Clonburris SDZ, Reg ref: SDZ22A0010  
Dublin 22

Ronan Mac Diarmada & Associates

## COMPLIANCE RESPONSE

July 2023

## Condition Request 2(c)

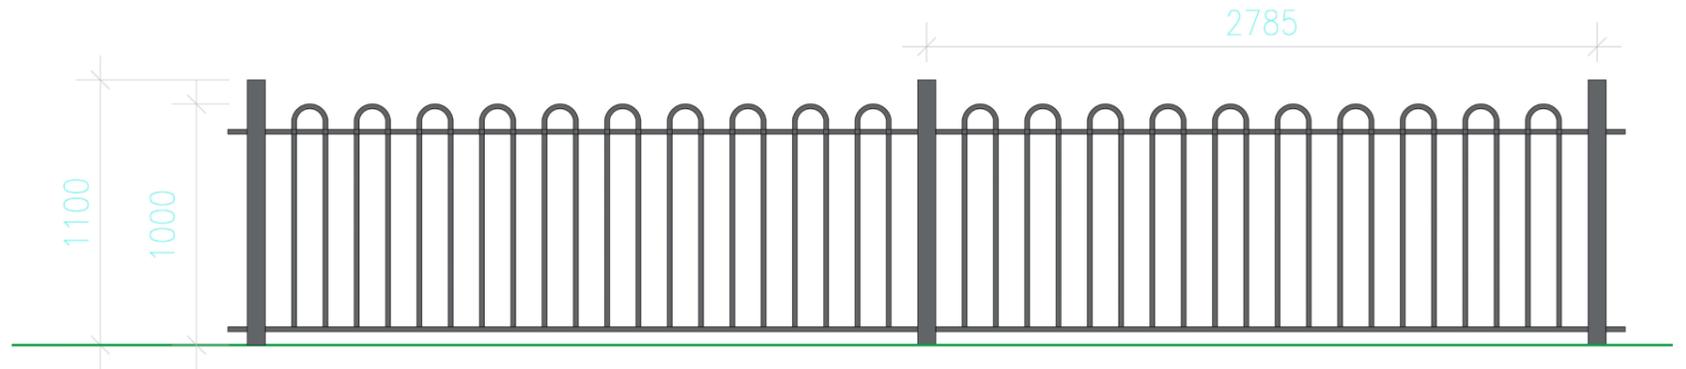
Revised boundary plan clearly showing the proposed boundary treatments for the scheme. The northern and eastern boundaries should be revised so that any boundary walls along these boundaries are no more than 1.0m in height. Planting and landscaping shall be reduced in height and/or provide for adequate passive surveillance.

Please refer to Dwg02 Boundary Plan, for more details on boundary treatments in the scheme. The northern boundary wall has been reduced in size as per request. A native hedge shall be planted to the inside of the wall.

**1.0m high Bowtop Metal Railing Galvanised,  
Powder Coated Black**

### Northern Green Corridor

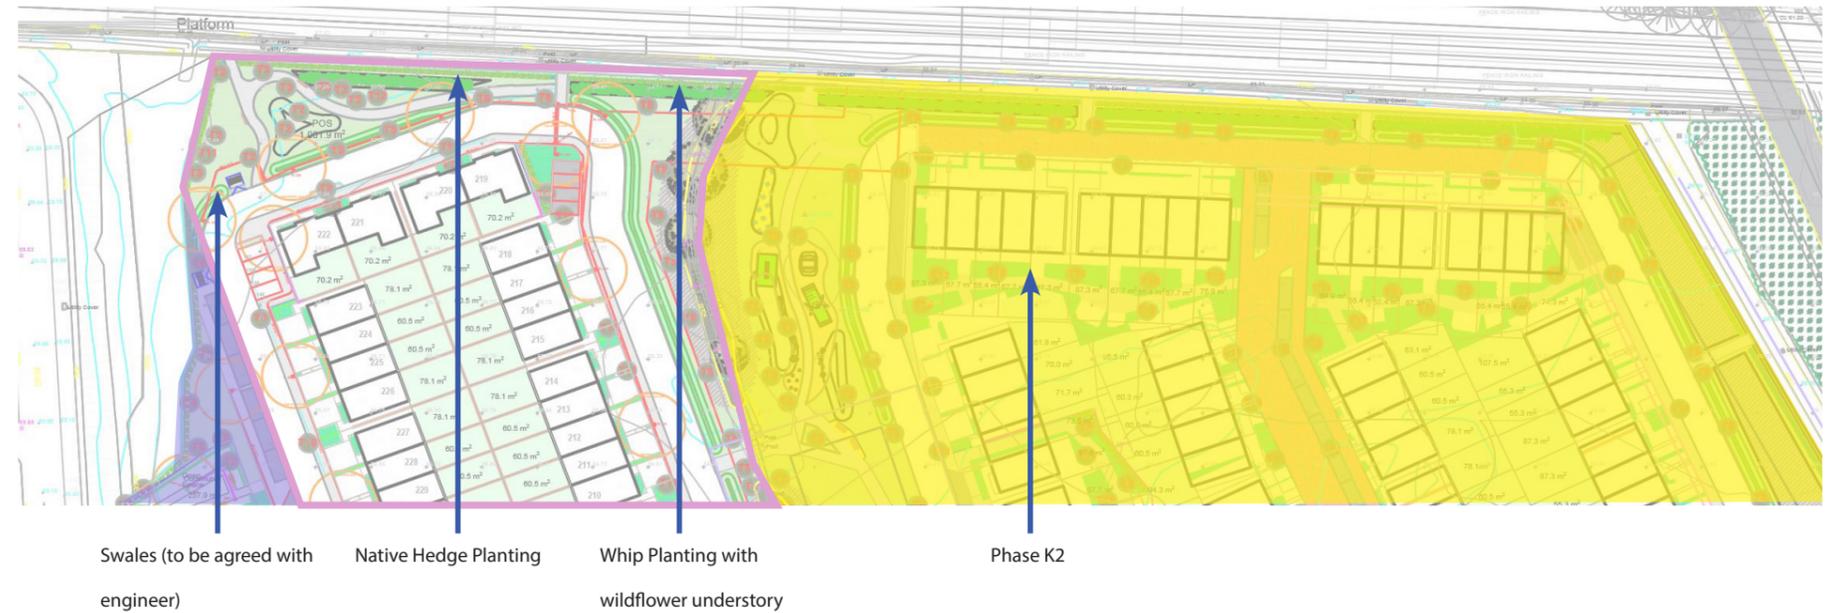
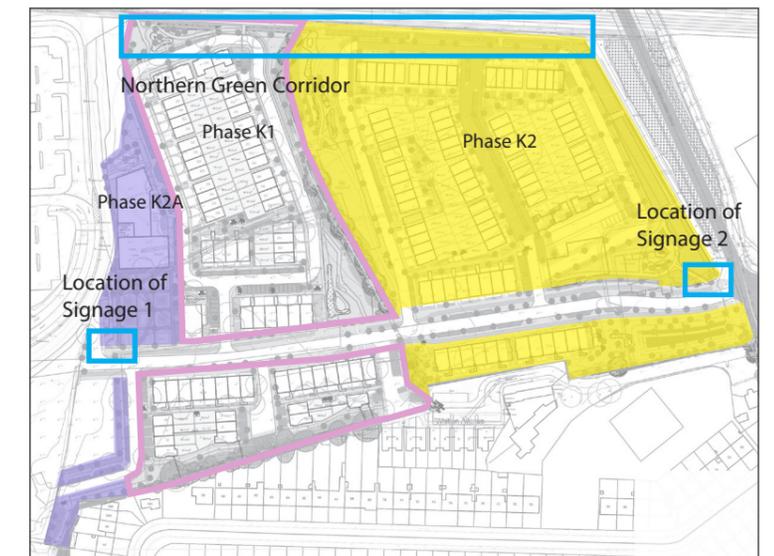
(i) A Strategic Green Corridor along the northern boundary of the site adjacent to the Dublin-Cork Railway including natural SUDs and planting along length of boundary (planting options might include Miyawaki style).

(i) A Strategic Green Corridor has been provided along the northern boundary of the site adjacent to the Dublin-Cork Railway. Whip planting and swales have been provided along this space.

Additional wildflower planting and a native hedge will be planted in this space to further enhance the green corridor.

### Eastern Green Corridor

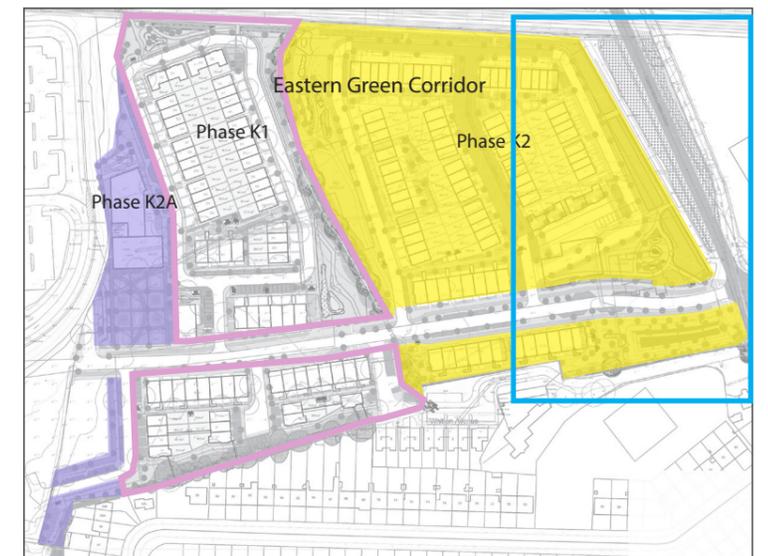
(ii) A Local Green Corridor approximately N-S along the eastern boundary incorporating nature based SuDS and planting along the length of the boundary.

(ii) A Local Green Corridor N-S along the eastern boundary has been provided with the use of Wildflower meadow planting and swales along the roadside. Street tree planting will also line the open space. (Part of Phase K2)

### Western Green Corridor

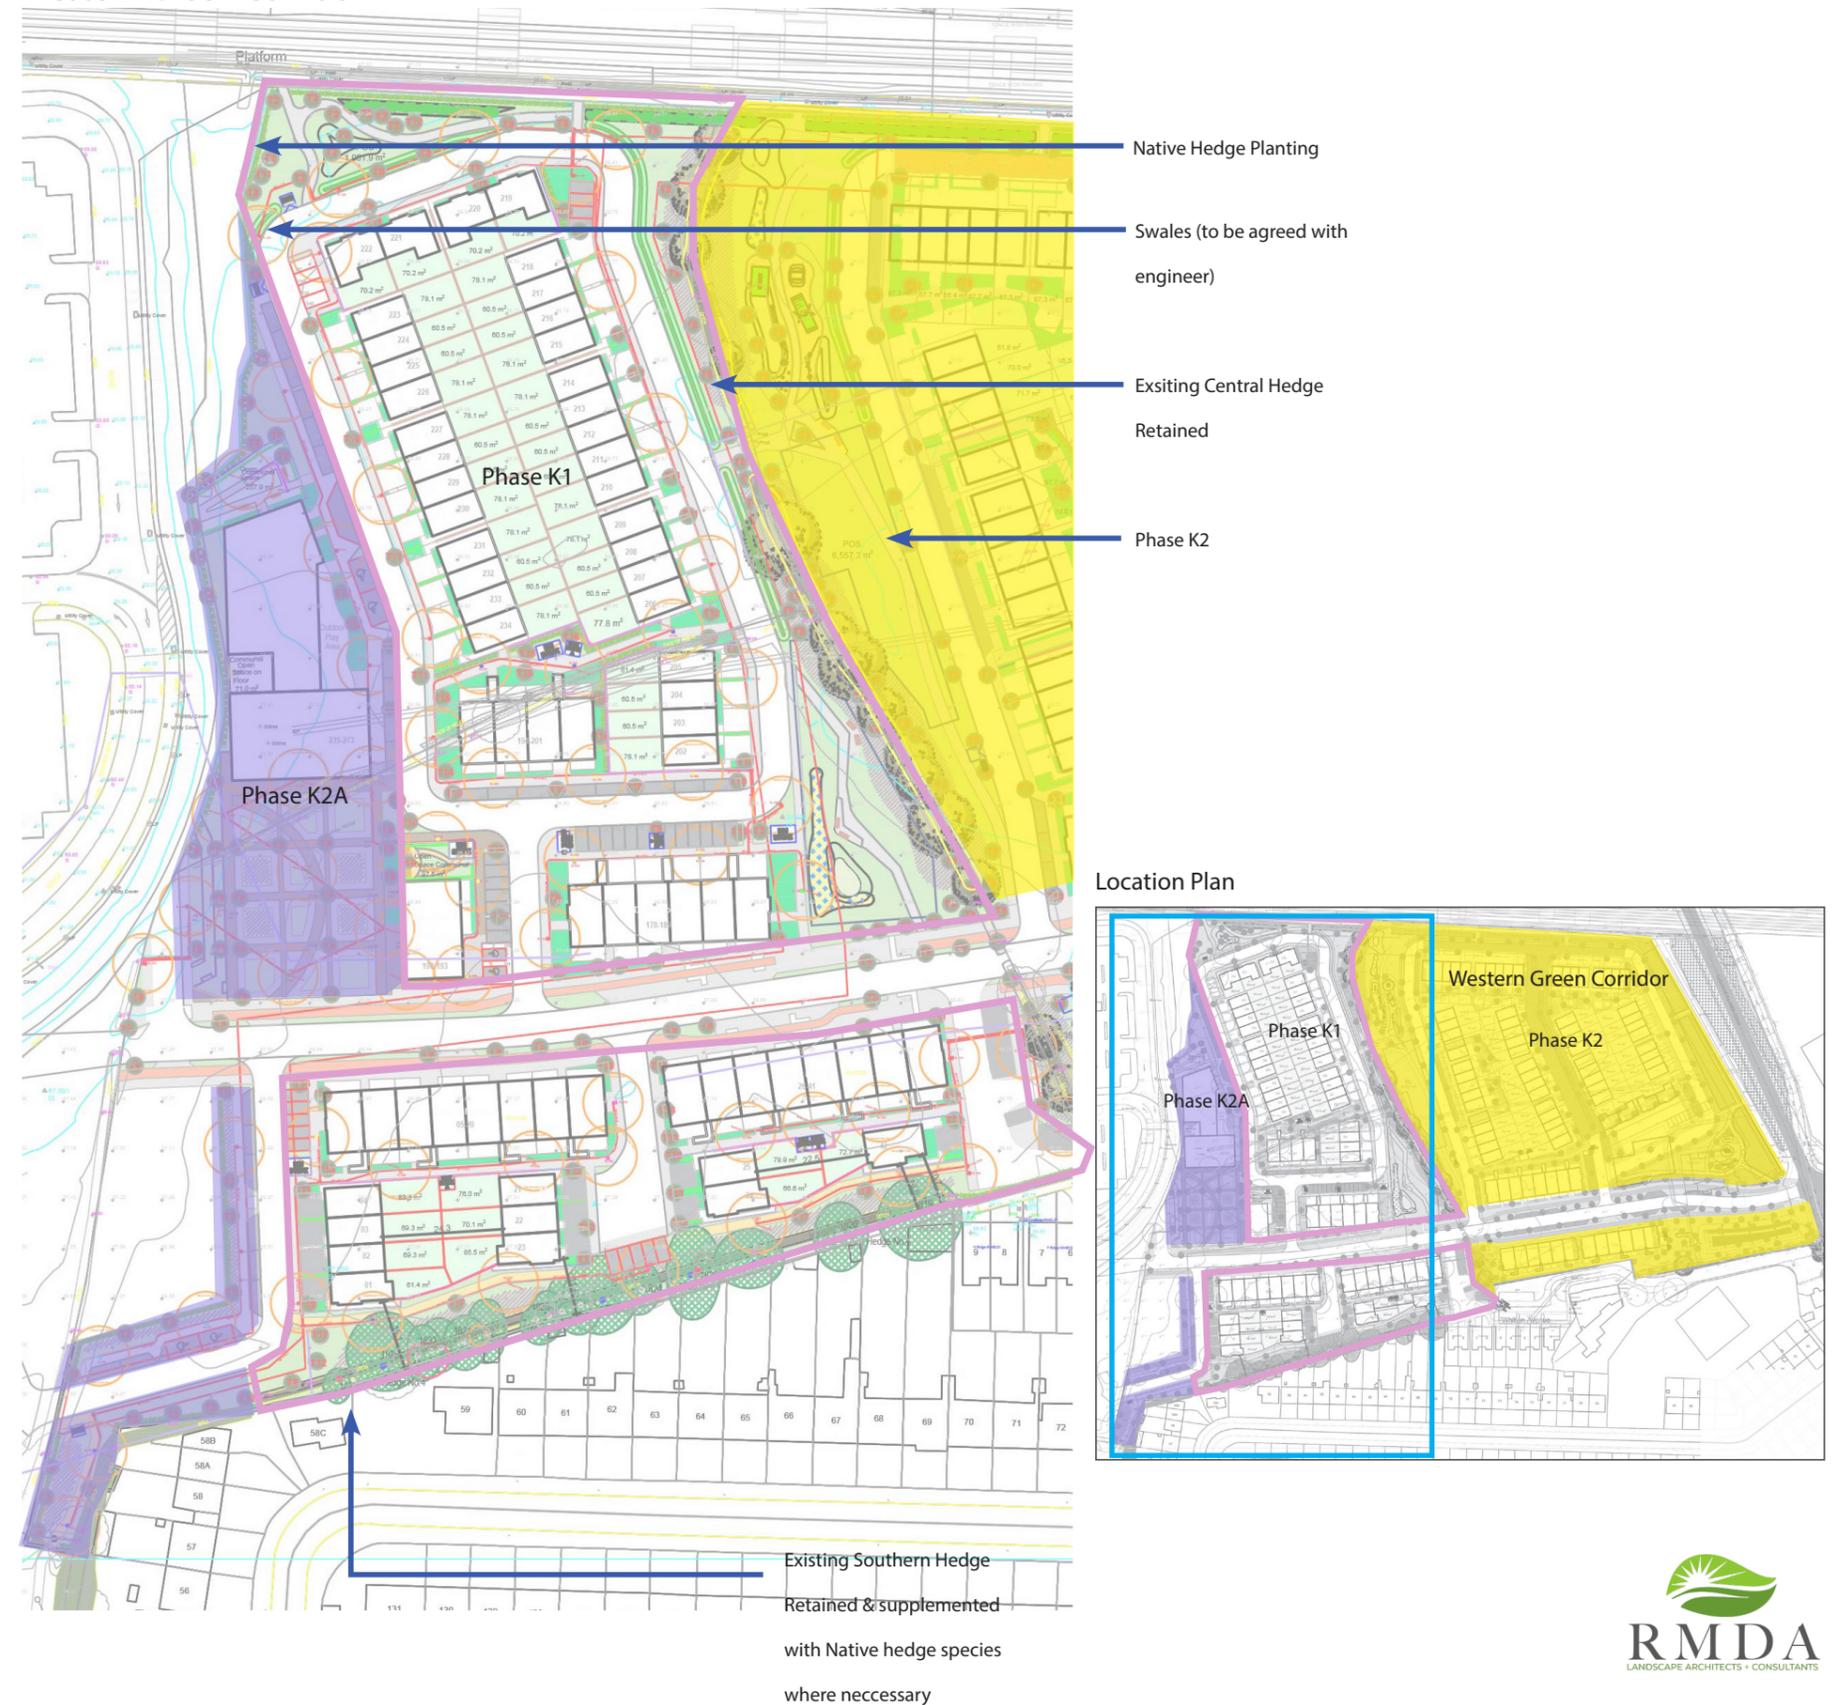
(iii) A Local Green Corridor approximately N-S and E-W along the westernmost local street south of Clonburris Link Street incorporating nature based SuDS: such as bioretention raingardens and additional planting

(iii) A Local Green Corridor approximately N-S and E-W along the westernmost local street south of Clonburris Link Street has been provided with the use of Wildflower meadow planting, native hedge planting and swales along the roadside.

Tree Pit Build Out Detail 1:50

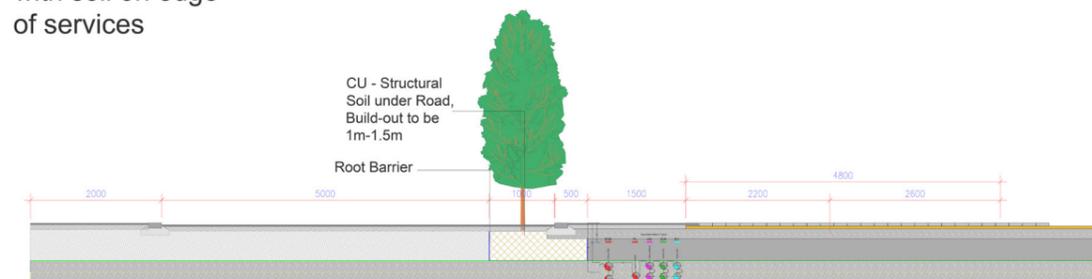
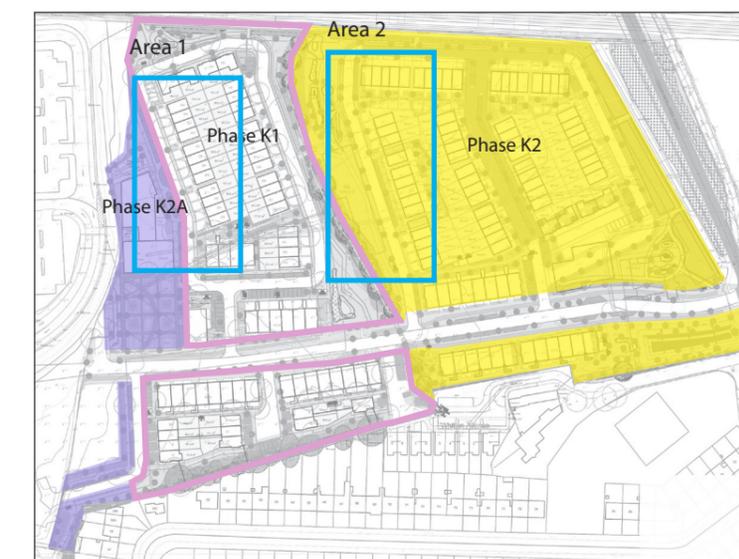
(a) Street trees required at the following locations: Outside house numbers: 192, 194, 196, 200, 202, 203, 190, 191, 189, 188, 187, 185, 183, 181, 179, 177, 175, 174, 172, 125, 126, 127, 129, 131, 133, 135, 137, 139, 140, 142, 107, 109, 111, 113, 115, 117, 119, 121, 122, 124, 123, 92, 90, 89, 87, 85, 83, 82, To enable the tree to be in the street the footpath should be moved to the inside, (i.e. car parking and tree on the street edge).

(a) Street trees have been provided where possible outside the house numbers mentioned above in the item. With agreement with SDCC, street trees will be provided in tree pits, approximately every 20m along the roads. Please refer to section of tree pit, with buildout to roads.

### Western Green Corridor

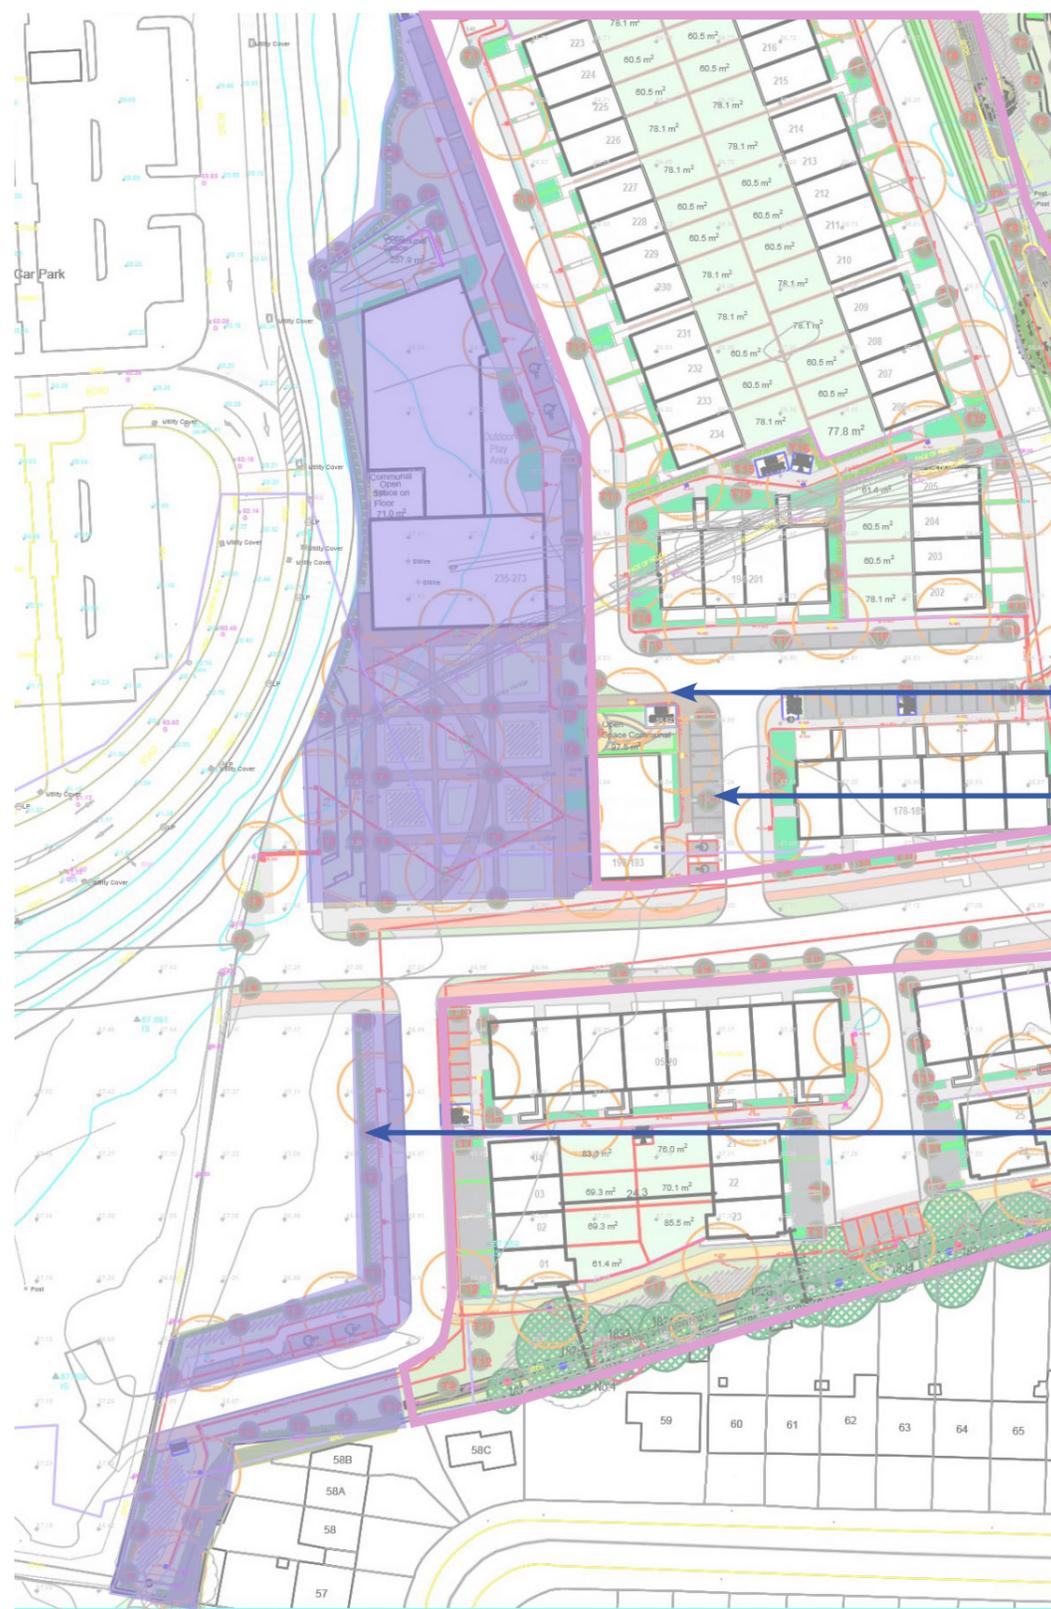
(b) Additional street trees required to address the gap in street tree provision along the Local Green Corridor connecting the canal to the urban plaza. Enhanced planting shall be provided by additional street trees, planted swales or small scale SuDS as appropriate to create a Local Green Corridor along this street. The applicant is referred to the Clonburris SDZ Planning Scheme 2019, Clonburris SDZ Parks and Landscape Strategy and DMURS (2019) for guidance on street tree provision and appropriate design layouts for local streets and homezones.

Landscape masterplan/planting plan to clearly delineate street lighting to ensure street tree proposals are realistic. If this is not currently the case, proposals to be revised to ensure street tree delivery.

(b) Street trees have been provided along the Local Green Corridor, connecting the canal to the urban plaza with the use of wildflower meadow planting and native tree & hedge species.

All street trees that are planted within the public realm will have a tree pit incorporating SuDS features. Please refer to tree pit detail shown.

Street trees will be 18-20cm on the local streets, & 16-18cm on intimate local roads, ie. homezones.

The revised landscape plan incorporates the revised street lighting, ensuring the tree planting proposals are realistic. A 5m exclusion zone has been provided to mitigate any potential clashes with the tree planting plan.

### Central Open Space

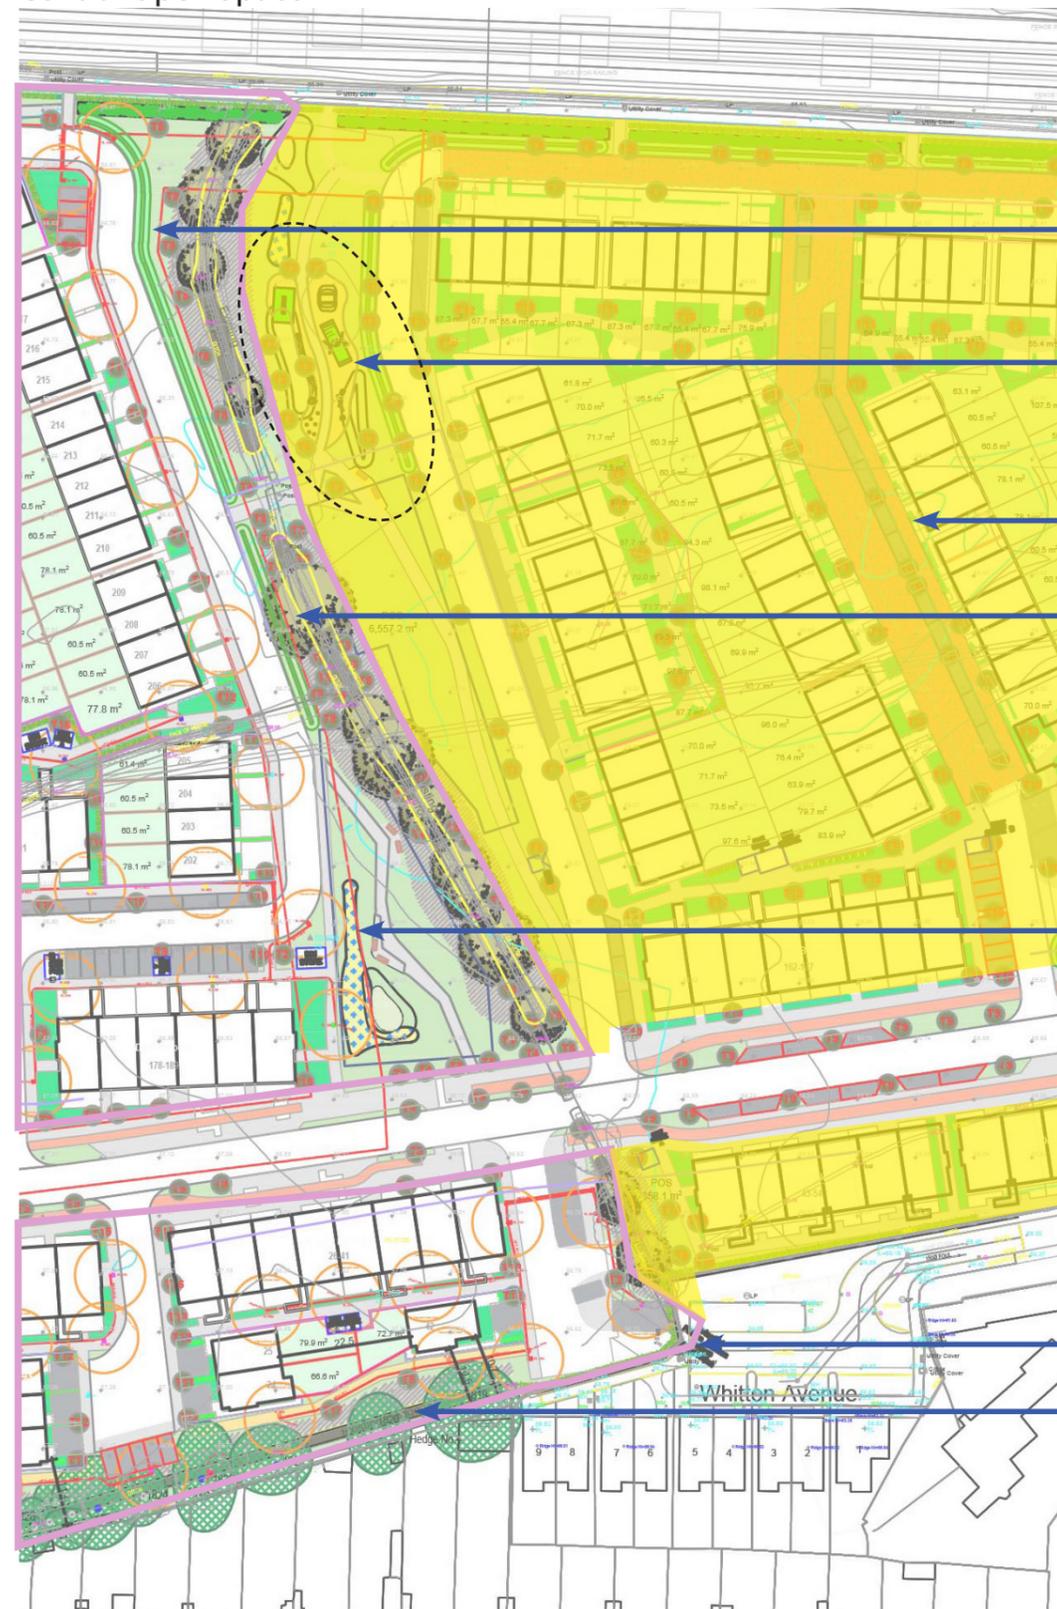
(iv) Revised play design at central open space

(v) Open space areas along all roads to incorporate natural SuDS for attenuation, water treatment, amenity and biodiversity purposes as outlined in SDZ. Details of all natural SuDS features including swales, rain gardens, bioretention tree pits, channel rills, filter strips, ponds, detention basins with lower areas allowed to fill first (low flow channels), wetlands etc. to be agreed with Public Realm

(iv) The central open space has been revised to incorporate SuDS elements as well as revised play items. (Part of Phase K2, subject to change)

(v) Open space areas along all roads incorporate natural SuDS for attenuation, water treatment, amenity and biodiversity purposes as outlined in SDZ. Please refer to details shown for treatment of swales and detention basin as per coordination with Engineer.

- Swales (to be agreed with engineer)
- Play area Revised, natural play elements used (Part of Phase K2)
- Phase K2
- Wildflower understorey to Existing Hedge & Trees
- Bulb Planting
- Native Hedge Planting
- Existing Southern Hedge Retained
